PREVOST

WARRANTY BULLETIN

WB14-55

DATE :	DECEMBER 2014	SECTION :	16 - Suspension
EXPIRATION:	DECEMBER 2016		
SUBJECT :	SHOCK ABSORBER MOUNT NUTS ON IFS

Figure 1

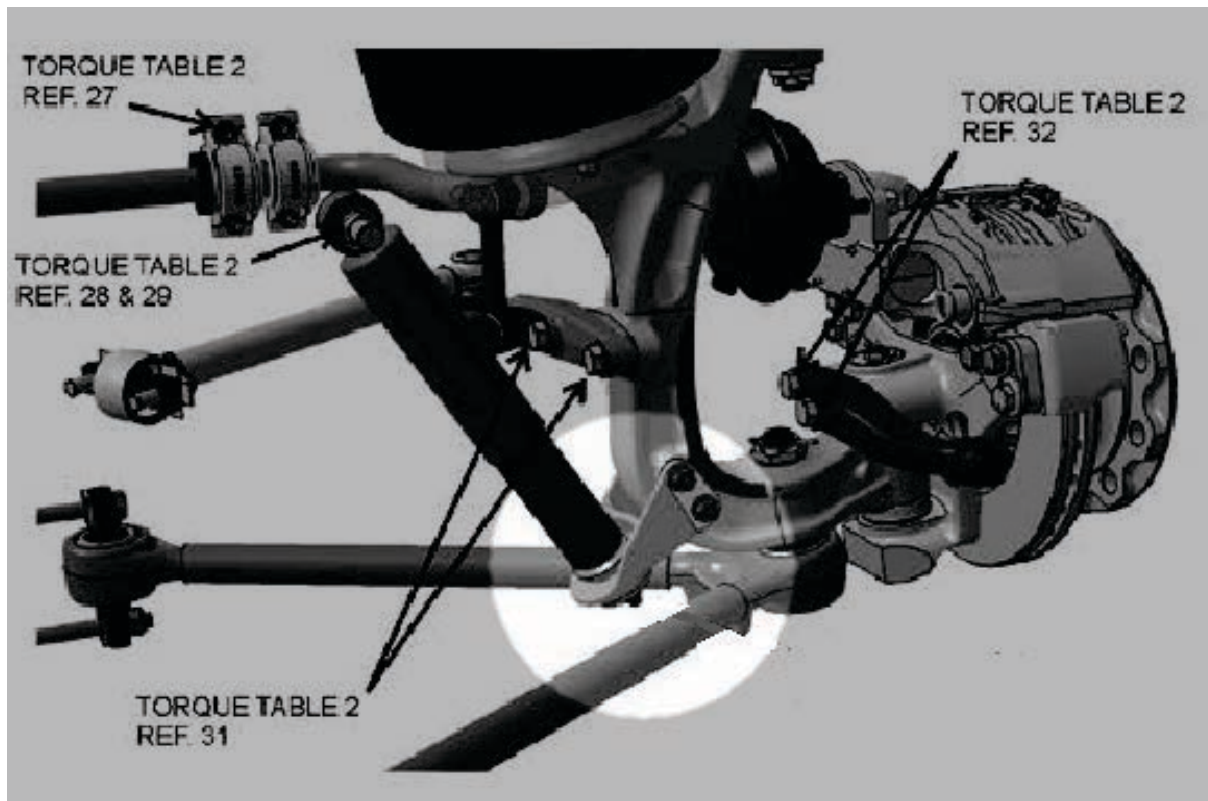
1. Inspect the nut head profile on the anchor bolts of the shock absorber mounting.(Fig.1)
2. Nut head profile must not show rounded corners. (Fig 2)
3. If round corners are found, replace bolt 5001790 and nut 5001771.
4. De-grease contact surfaces before re-assembly.
5. De-grease mounting bolt and let dry.
6. Tighten to 155 lbf-ft.
7. Apply Valvoline anti-corrosion agent.
